**M54 to M6 Link Road**

**TR010054**

**8.25 Applicant Responses to Examining  
Authority's Further Written Questions  
and Representations Made at Deadline 5**

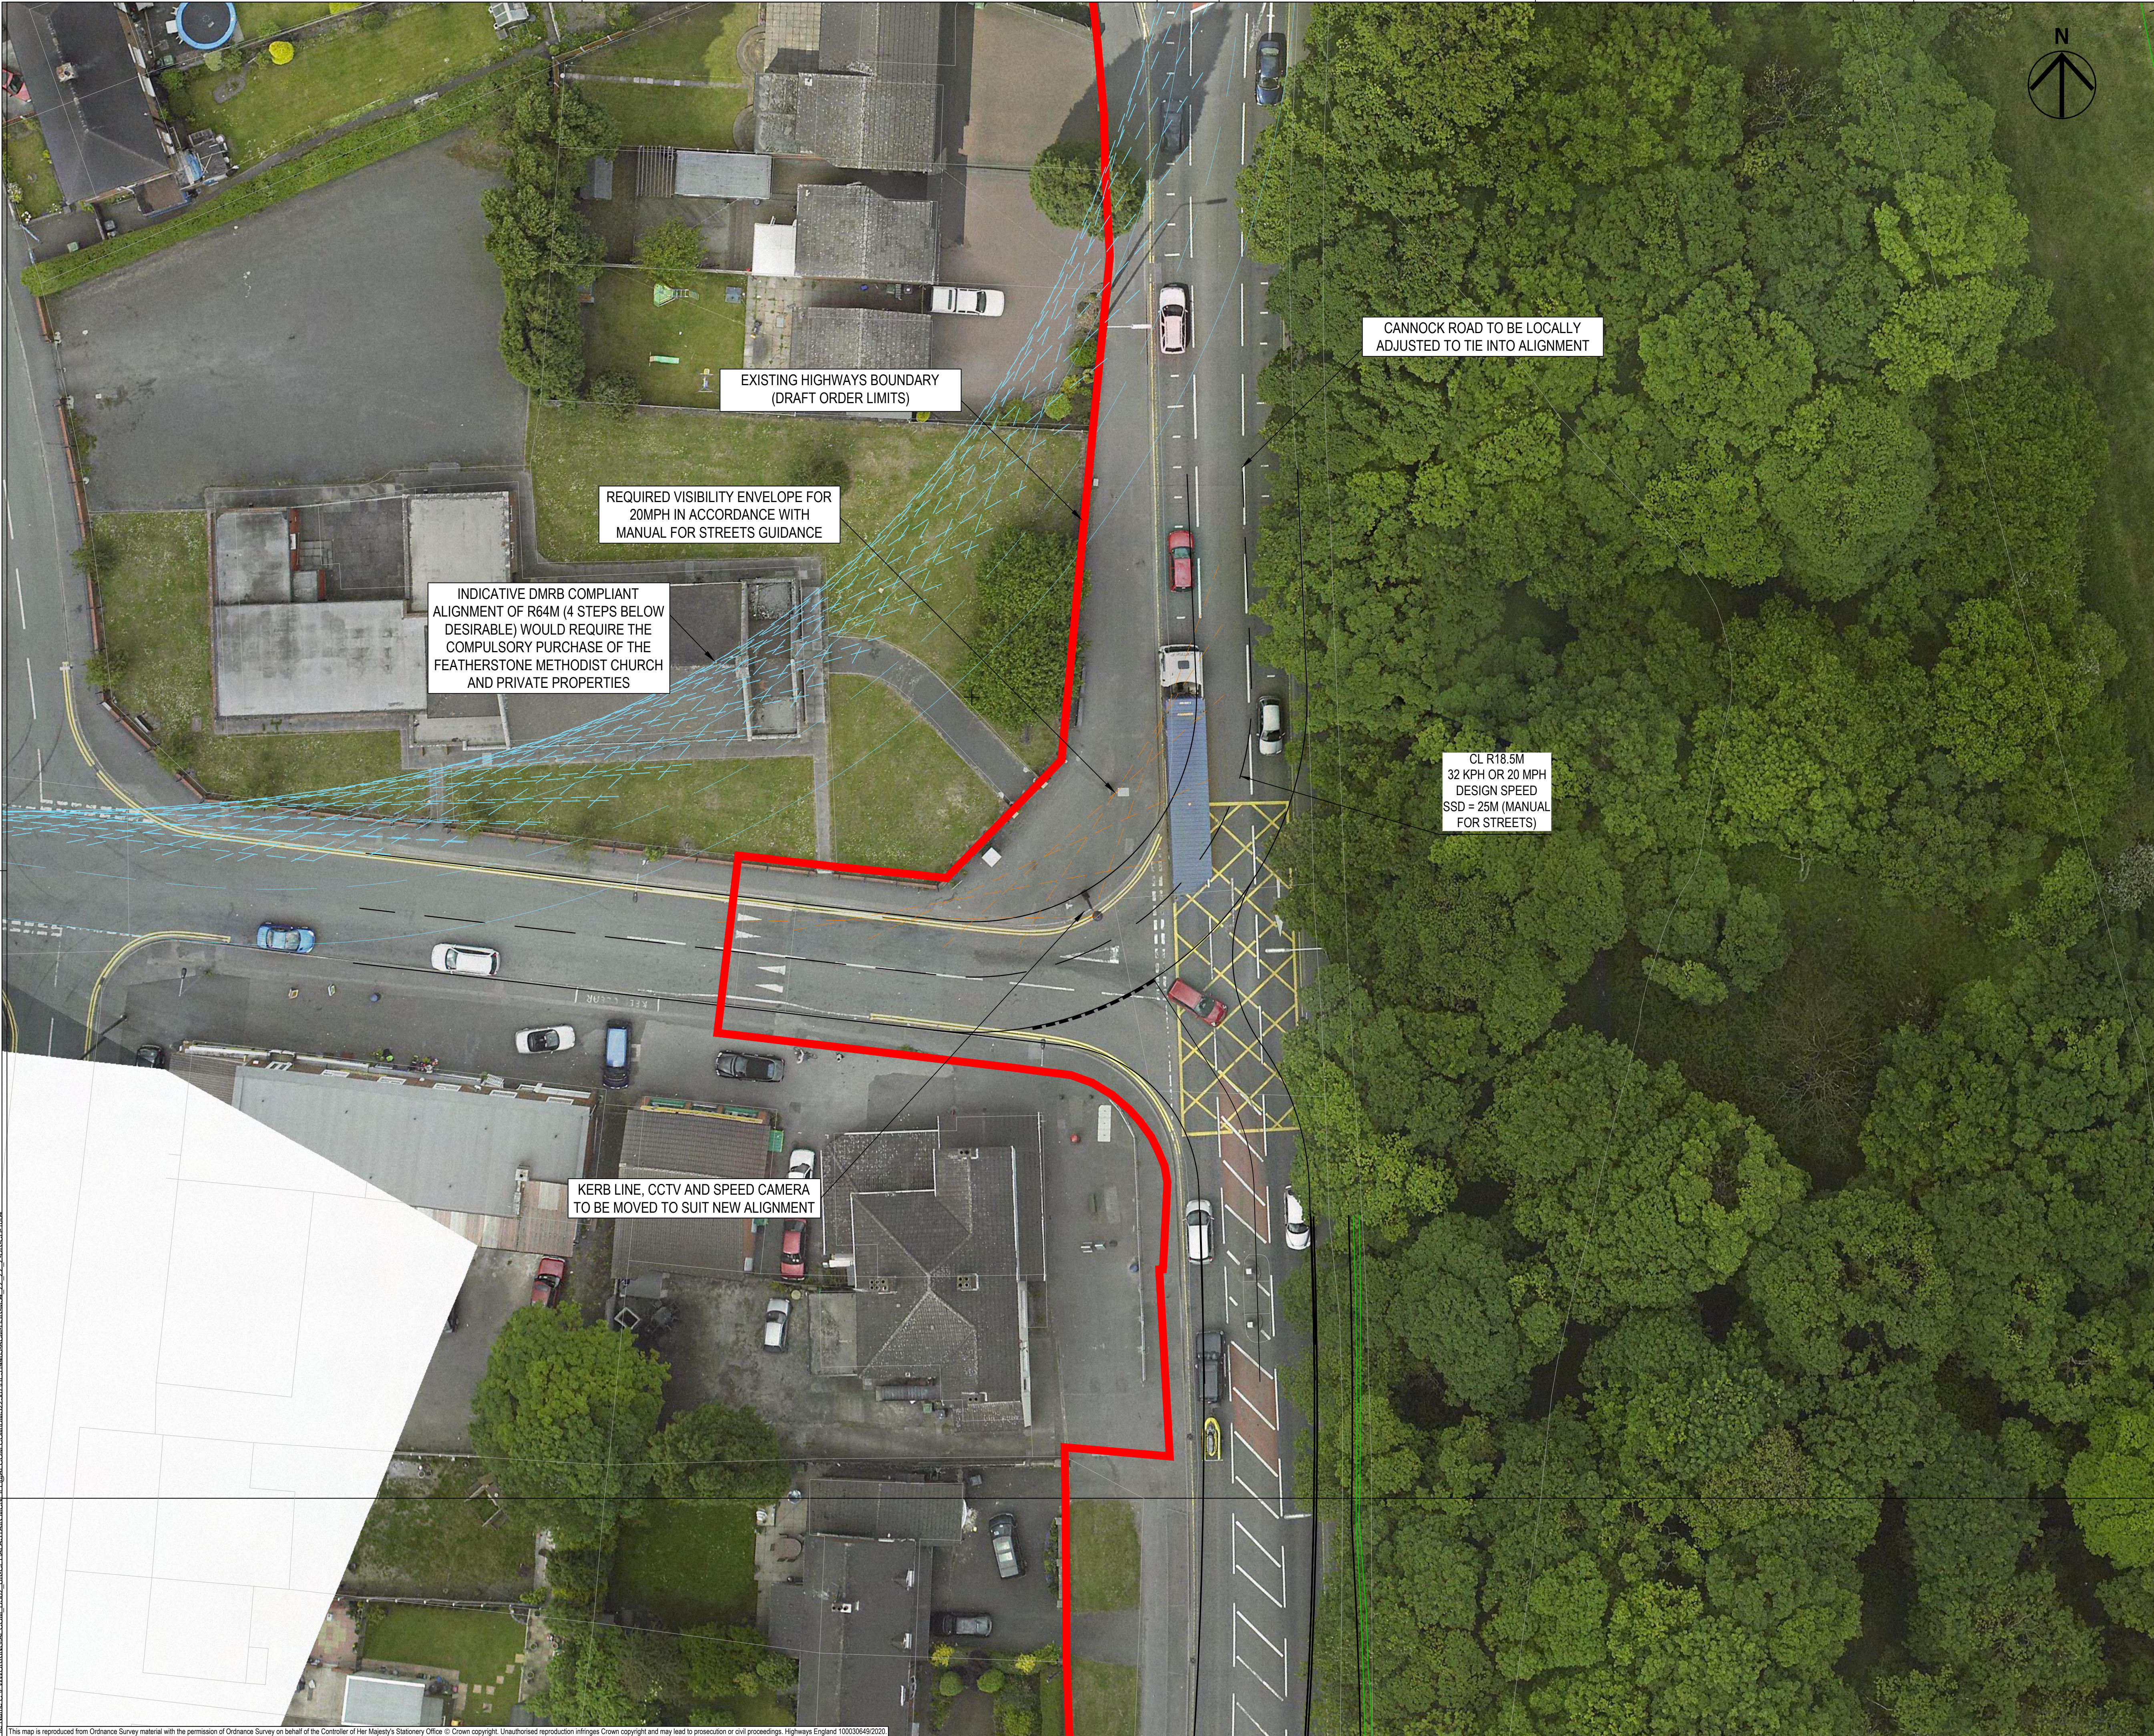
<p>As the applicant has stated 'many' of the kettle hole features is not the same as saying 'all', there is the suggestion that some of these features are kettle holes and therefore may contain Holocene spanning peats. Any peat accumulations which do persist without significant human disturbance are worthy of comprehensive analysis so that the information they may contain is retained for future generations and research.</p> <p>If something is not recorded that does not mean it does not exist, especially where robust <a href="#">hypothesis and</a> modern, detailed satellite images suggest otherwise. I agree that it is likely that some, if not many, of the features may not be kettle holes or that they may have been kettle holes which were incorporated into the historic parkland of Hilton Hall. A preliminary screening of what features in the affected landscape may be 'new' artificial ponds or</p>	<p>None of the features identified as possible kettle holes by Mr Williams are kettle holes. As stated previously, these features represent former quarries which have since been infilled, or are not ponds at all, but rather locations of scattered parkland trees or gaps in woodland areas.</p> <p>The former quarries can be seen on historic Ordnance Survey maps in Figures 6.9 and 6.10. These maps also show that features, such as the pond to the west of Home Farm and north of the M54, were not present, with this area formerly representing an area of woodland.</p> <p>The locations identified to the west of Hilton Hall are located within woodland planting created in the early 19<sup>th</sup> century (between 1897 and 1916). This is the area named as Lower Pool. There are no landscape features located on mapping of 1796 (see Figure 6.7), so it seems unlikely that an earlier feature was used to base the pond location on. It is not known if a Repton Red Book exists. The report produced by Tarmac (1989) included research by Cherry Ann Knott, and she reviewed available documentary sources</p>

Representor	Topic	Representation	Applicant's Response
		<p>modified kettle holes would have been much more easily facilitated had the applicant taken the time to fully investigate the role of landscape gardener Humphrey Repton at Hilton Hall in the late 18th and early 19th centuries. There is a very real possibility that an unknown 'red book' design for Hilton Hall may still be held by the descendants of the hall's historic owners. The opportunity to combine the historic record (a Repton red book) and modern scientific techniques (coring and proxy palaeoecological analysis) is a missed opportunity to the detriment of all.</p> <p>It would have been helpful if the ExA had sought the advice of a palaeoecological specialist not currently contributing to the examination or broadened out the discussion on this matter to other contributing parties in the way that I advocated at Deadline 2.</p>	<p>held by the family. Despite representation from Allow Ltd, there is no mention of a Red Book in this document. Notwithstanding this, there is no evidence for a kettle hole here previously. The <u>Glaciofluvial Sheet Deposits</u> generally associated with kettle holes are also not identified in the area on the <u>geology maps</u>.</p> <p>Further north, the indicated features are ponds shown on the first and second edition Ordnance Survey maps. Most are in locations that will not be impacted by the Scheme.</p>

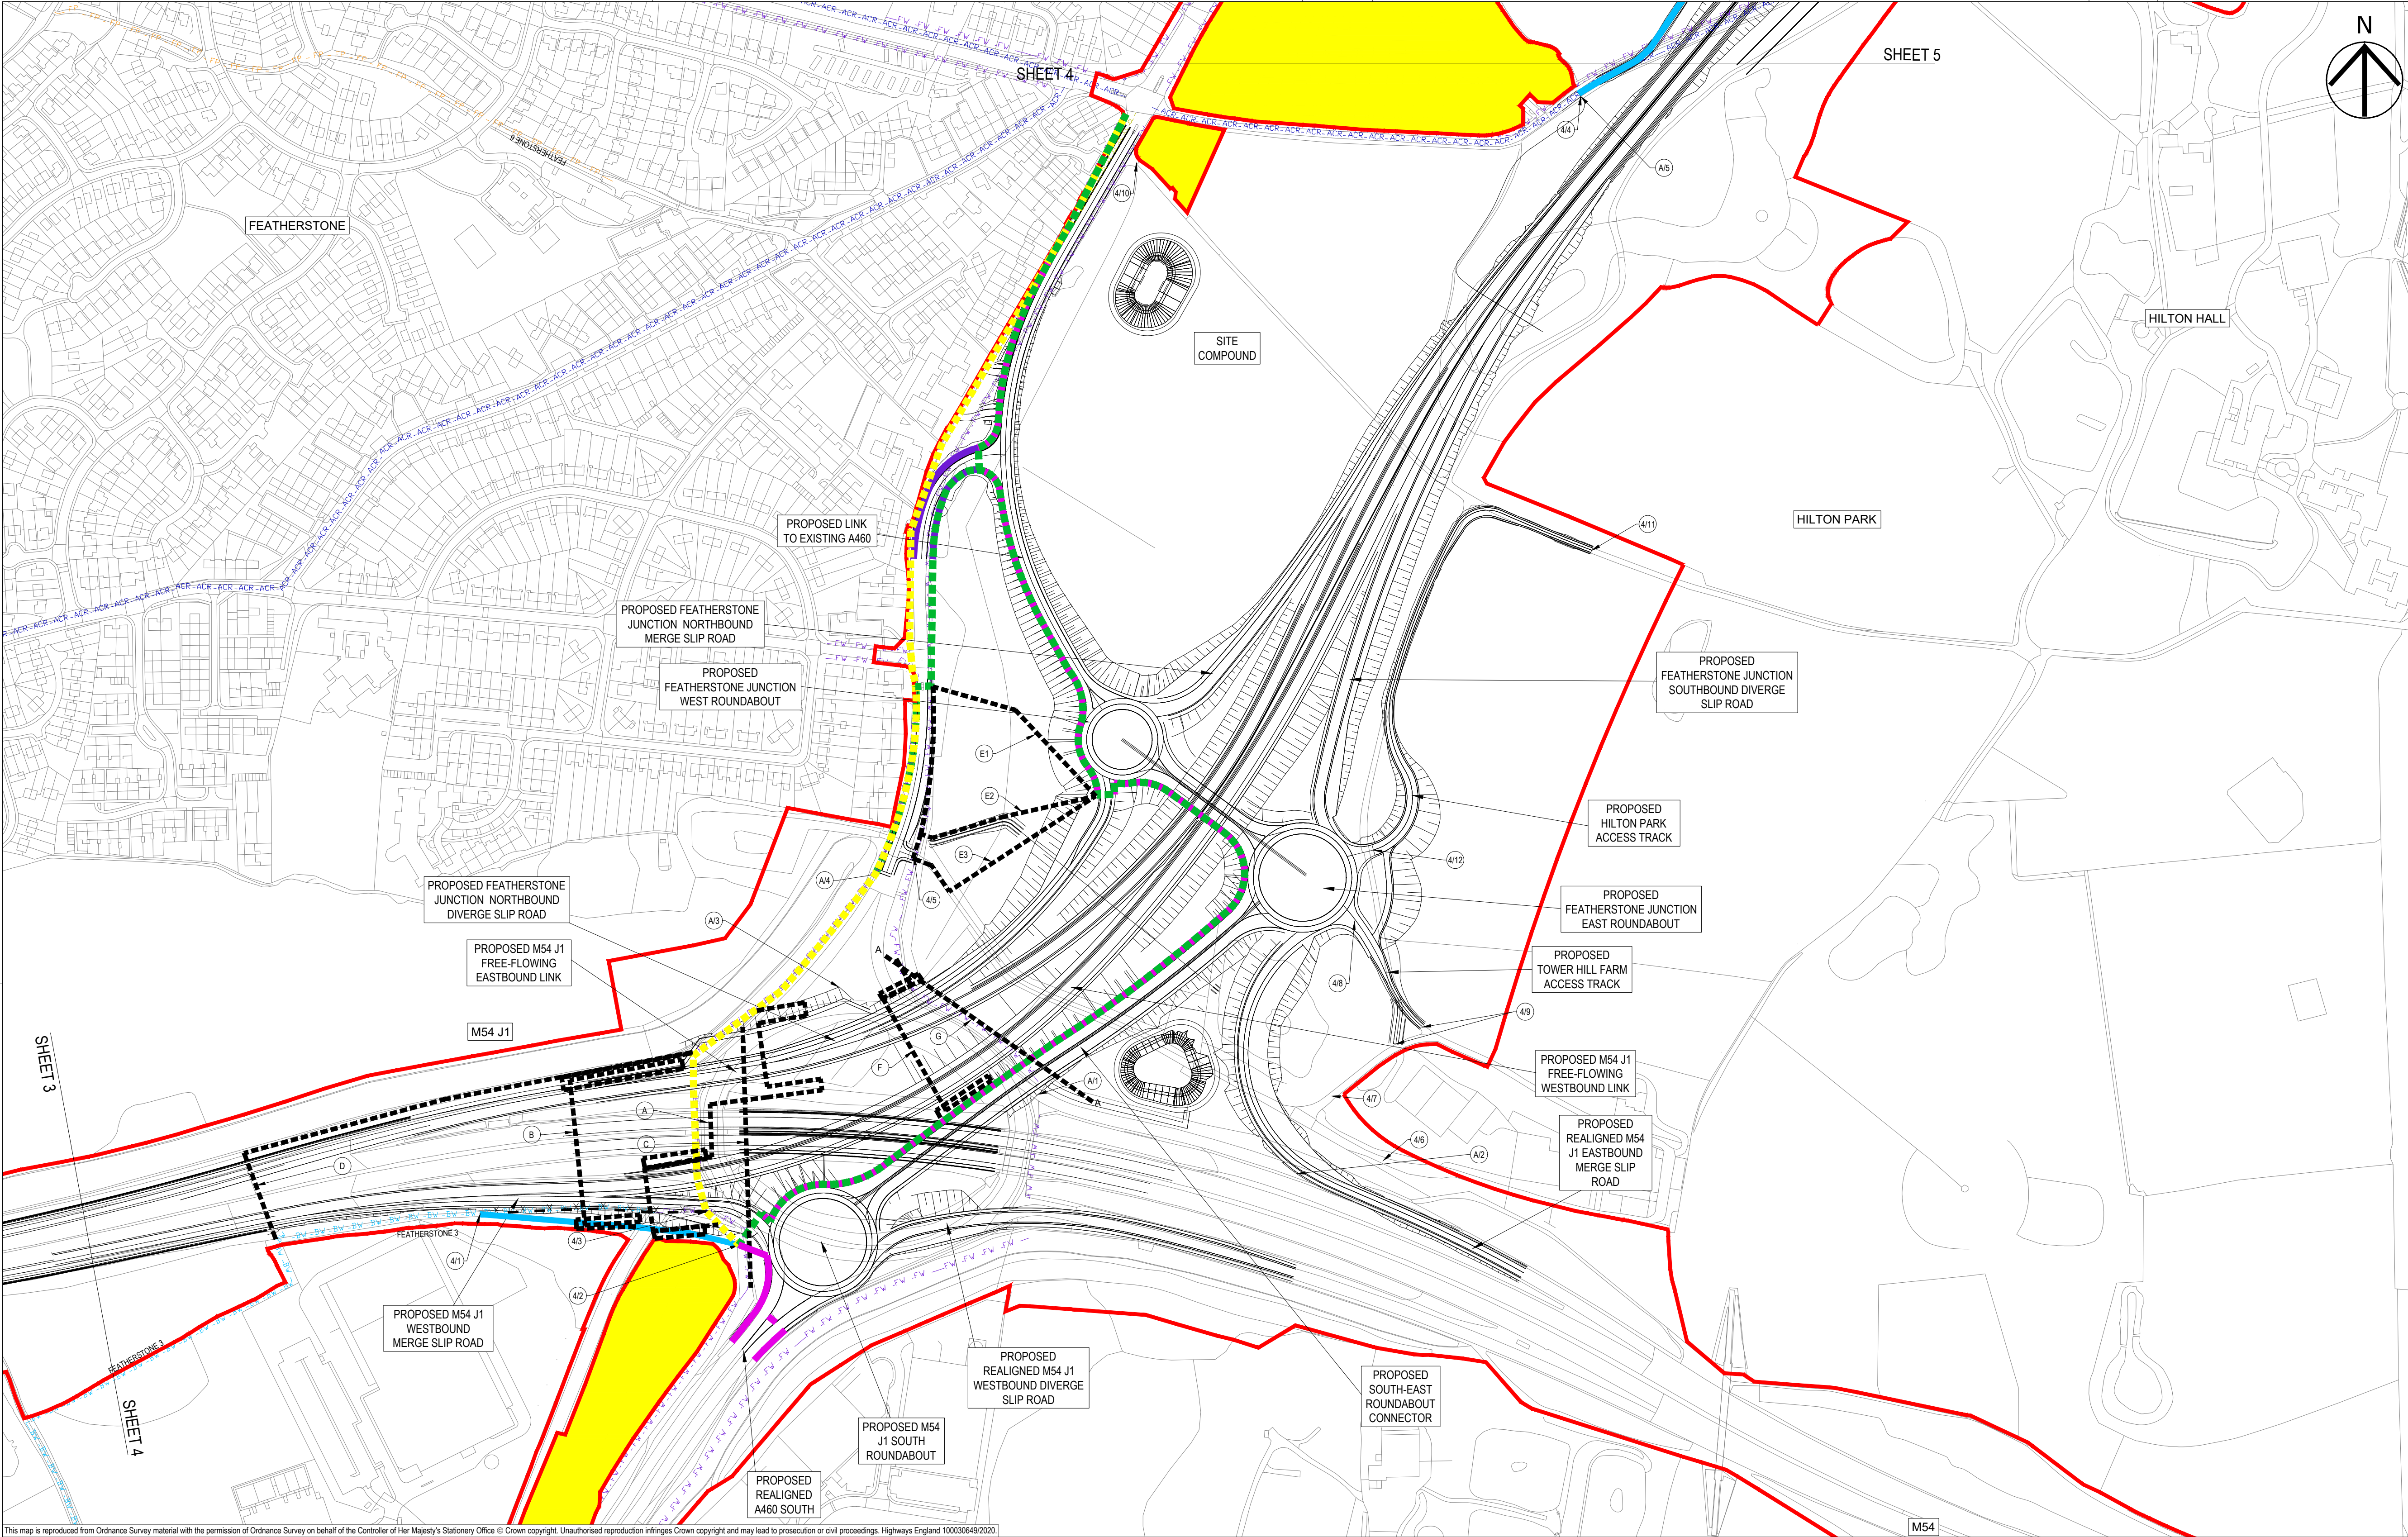
3.10.6	The Applicant	<p><b>Transport Assessment Report</b></p> <p>The ExA thanks the Applicant for its response to ExQ2.10.1 given at [REP4-033]. For clarity, could the timings for Route 1 be re-run for the same end points, but by travelling along the new link road rather than via the existing A460?</p>	<p>Tables have been added to this document at Appendix 3.10.6.</p> <p>The start and end points for Journey Time 'Route 1' remain as documented in the Transport Assessment [REP3-036] in section 4.9 "from A460 (Stafford Street) to M6 Toll Junction T8" and therefore includes predicted time delay effects on links beyond the Order limits.</p> <p>The predicted travel times for 'Route 1' have been tabulated for the 'Do-Minimum' case along the A460, for the 'Do-Something' case along the existing (bypassed) A460, and for the 'Do-Something' case along the new Link Road. Journey time differences are compared against the 'Do-Minimum' case.</p> <p>Also included at Appendix 3.10.6 is a Table of Journey distances, which vary from the 'Do-Minimum' case because the Scheme would reconfigure M54 Junction 1.</p>

Note: All values in minutes and seconds. Negative differences (red) are journeys predicted to take a longer time with the Scheme

SECTION ALONG UNDERPASS ROUTE OPTION C  
(N.T.S)

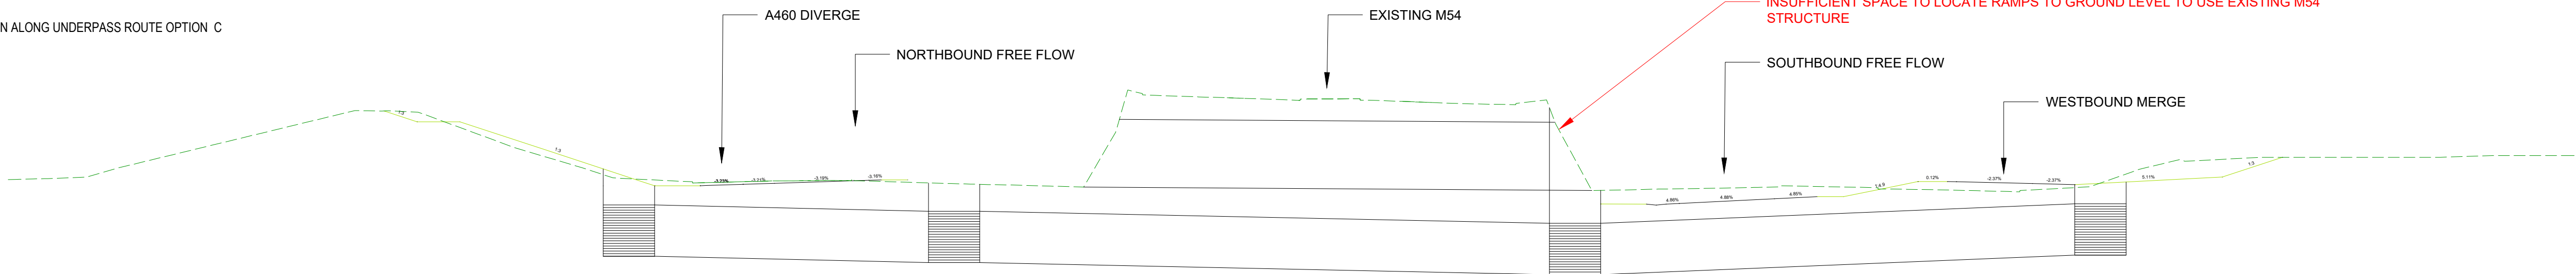
Alternative footpath route	<p>It can be seen from the bus route of the No 70 in figure 7.5 that the applicants preferred route is a much longer journey for residential walkers and wheelchair users to negotiate, In 2.10.12 [interested parties] I was asked if I consider an average walking speed of 4 mph to be realistic, my answer to that is No, the ramblers association states that 4 KM per hour is a realistic average walking speed, speed will vary between a fit 20 year old to a 60 plus less mobile person and wheelchair users also need to be considered, I note the applicant has considered this group when dismissing an overhead bridge over the M54 link workings.</p> <p>I suggested using 4 KM per hour at the hearing in December but the applicant chose to ignore my comments preferring to use a walking speed of 4 mph and stating that their route would only take 13 minutes and 30 seconds to walk their proposed route, having to cross an un-controlled carriageway crossing which is acknowledged by the applicant as a MAJOR IMPACT under the design manual for roads and bridges LA 112 [para 2.2.6 applicants response] under my proposed 4 KM per hour calculation the journey referred to above would take 21 minutes using the applicants previously stated distances and times which the applicant has stated as being undesirable [2.4.6] and is far too long compared with the present journey time of 8 to 10 minutes and it could well be reduced once the M54 slip roads onto the A460 are removed when the scheme is implemented.</p> <p>I am confused that the applicant persists in comparing their preferred route with the existing situation on the A460 route, when if my proposal for a direct route using</p>	<p>The typical walking speed of 1.4 metres per second (5.0 km/h; 3.1 mph; 4.6 ft/s) is recommended by design guides including the Design Manual for Roads and Bridges. For the purpose of route assessment an average walking speed of between 3-4 mph has been used in the Walking, Cycling and Horse-riding Routes at Junctions Technical Note [REP4-035/8.2] therefore it is considered that the assessment is a realistic representation of journey times.</p> <p>Further clarification was provided at the meeting with the Parish Council regarding the engineering constraints at M54 junction 1 that govern why 3 underpasses cannot be provided and a single underpass of 100m in length would be required. A long section of the proposed underpass route has been included in Appendix 3.10.8 to aid understanding. Based on the Parish Council meeting it is considered that this has been communicated and understood.</p> <p>Leading on from the Parish Council meeting two additional route options at M54 Junction 1 have been assessed at the request of Cllr Cope; Option F and Option G, which would be to provide an underpass or overbridge on the eastern side of M54 Junction 1 to cross the free flow slip roads and local connector road. Refer to Appendix 3.10.8 for further details on proposed route alignment.</p> <p><u>Option F</u></p> <p>This route would pass to the east of the junction rather than the west to allow additional space for the structure. It would require a structure length in excess of 80m, crossing both the north and southbound free flow link roads. It would require approach ramps each 140m long, resulting in a total increase of</p>

Representor	Topic	Representation	Applicant's Response
		<p>underpasses would eliminate having to cross the M54 slip roads because they would no longer be in existence once the scheme is built and therefore would have NO MAJOR effect. My proposal should include a well-lit walking and cycling path and access for wheelchair users in order to access the employment facilities at Hilton Cross, it would be the shortest journey time of 8 minutes and prevent having to use a motor car in order to travel the applicants alternative route of 21 minutes.</p> <p>I note the applicant says that an underpass would be 100 M in length however the walkway would have to pass under two connecting roads to the scheme together with and the main M54 above which is what pedestrians have to negotiate at the moment, I would therefore like to request a digital virtual design showing how the three underpasses could work in my proposal and the 100 M underpass suggested by the applicant so that the designs can be scrutinised.</p>	<p>280m over the structures in addition to the longer route around the east of the roundabout (total distance from point 4/2 and the Junction of The Avenue with Cannock Road would be 880m). As previously noted, pedestrian bridges over the carriageway are undesirable for users as they are linked to antisocial behaviour due to their isolated nature and are not considered pleasant to use. The new pedestrian bridges and connecting routes would be away from the carriageway in its entirety and would not be overlooked by any adjacent properties, even though the route would be lit, it is anticipated that this route would be undesirable to certain vulnerable users especially at night due to concerns with personal security, leading to a high degree of social isolation and community severance.</p> <p>The structure would also provide steps which would reduce the proposed distance. Using the stepped approach, this would only increase the distance by a total of approximately 150m. However, in accordance with inclusive design guidance the route suitable for all users (including cyclists and wheelchair users) has been assessed. This demonstrates that once the approach ramps are taken into account then the increase in distance is greater than that of alternative options which may be more desirable to users (such as Option E1 - total distance from point 4/2 and the Junction of The Avenue with Cannock Road would be 750m). Overall, the reduction in length for walking users able to navigate steps is not anticipated to out-weigh the reduction in route length for certain users against alternative options as well as the risks associated with isolated sections of the network and the visual impacts of the introduction of new structures.</p> <p><u>Option G</u></p> <p>This option has been discounted as it would require an exceptionally long underpass, over 100m in length, which would be below the existing ground level resulting in drainage issues as well as the high likelihood of antisocial behaviour.</p>
